Response to Action Item 5-6 Section 5.4.2.1

MCB Issue List Regarding APR-1400, FSAR Section 5.4.2.1

Figure-1. Before and After Installation of Eggcrate Flow Distribution Plate

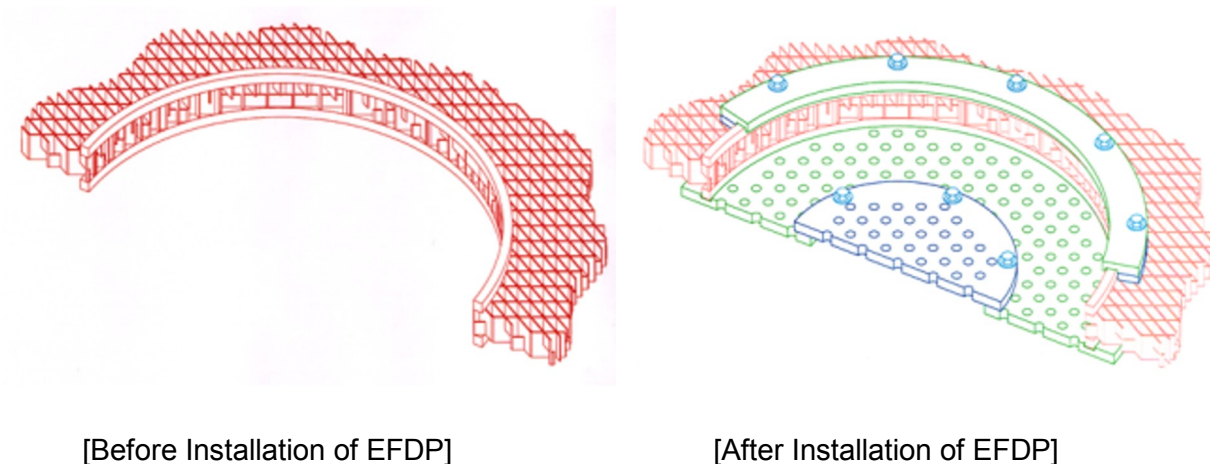
The discussion of tube supports in FSAR Subsection 5.4.2.1.2.2 states that this design has been proven to reduce wear in operating reactors.

Revise FSAR Subsection 5.4.2.1.2.2 to provide additional justification for the assertion. If it is based on operating experience outside the United States, provide information on this foreign operating experience to facilitate the staff's review.

Figure-1 shows the schematics before and after the installation of EFDP.

Comparison of tube wear status at U-bend region between those NPPs provides an additional justification how the EFDP design reduce the tube wear at central cavity region effectively. Tables 1 & 2 summarize the tube wear status (number of indications and number of tubes with indications) at U-bend region of Han-bit Units 5&6 and Han-ul Units 5&6 based on the recent eddy current test (ECT) results performed during their 6th in-service inspection (ISI). For the APR1400 steam generator, thermal-hydraulic analysis had been performed to investigate the optimum number of EFDP to be installed. Figure-2 presents the axial mass flux at central cavity region according to the number of EFDPs for OPR1000 and APR1400 steam generators. There is no such benefit to have two or more EFDPs. Thus, there is one EFDP at the uppermost full eggcrate for APR1400 steam generator.

The following statement will be added in Subsection 5.4.2.1.2.2:

“The operating experiences related to the tube wear status at Korean Nuclear Power Plants provide a justification for the assertion.”

[Downcomer Feedwater Ring]

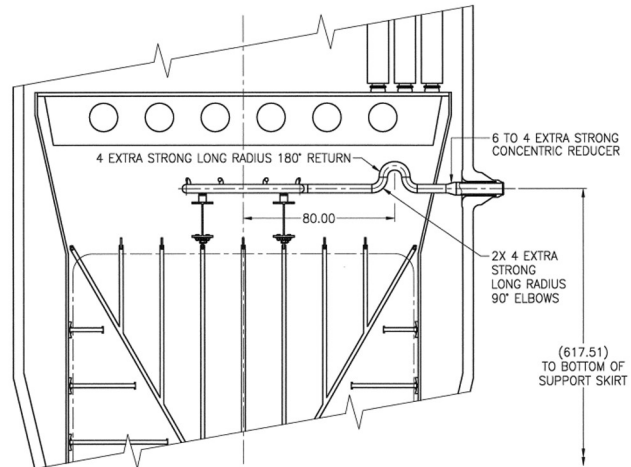
Providing adequate access for corrosion product and foreign object detection and removal is necessary to meet the requirements of 10 CFR Part 50, Appendix A, GDC 14 and GDC 15. Among the sources of loose parts are the feedwater components.

Revise FSAR Subsection 5.4.2.1.6 to explain the difference between downcomer feedwater and recirculation feedwater rings, and provide the location of the feedwater box.

The downcomer feedwater ring inside the steam generator applies the upward bend using a goose-neck design and I-type spray nozzles having small holes (hole diameter is 0.23 inch) and are installed to prevent the foreign object inclusion. Two I-type spray nozzles at each end of the piping is threaded into the piping, thus the two I-type spray nozzles can be detached from the piping to remove any foreign objects.
